**SUBJECT: Safety Recall 20S63**

Certain Front Wheel Drive 2014-2015 Model Year Taurus, 2014-2016 Model Year Explorer, and 2014 Model Year Edge Vehicles Equipped with a 2.0L or 2.3L Engine Front Halfshaft Bracket Replacement

FIGURE 1

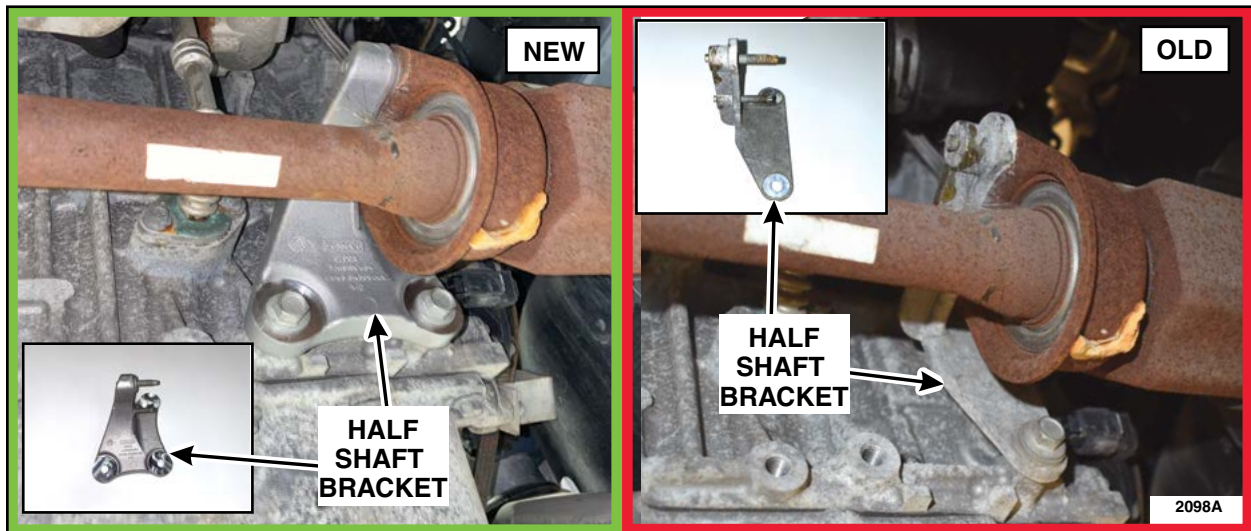
In some of the affected vehicles, the vehicle may experience a failure of the Front Halfshaft Bracket. A damaged Halfshaft Bracket can cause a vibration, grinding, banging noise from the driveline while moving. The bracket may fail without warning and could result in a loss of movement while driving. In some instances, there may be a loss of park function that could result in unintended vehicle movement, increasing the risk of accident. In addition, a failed bracket can allow separation of the halfshaft from the engine resulting in secondary damage to surrounding components.

**NOTE:** To see the old and *new* half shaft bracket. See Figure 1.

7. Install two (2) *new* half shaft bearing studs into the *new* bracket.

- Torque: 15 Nm (11 lb-ft).

8. Install the *new* RH half shaft bearing bracket and three (3) bolts.

- Torque: 48 Nm (35 lb-ft).
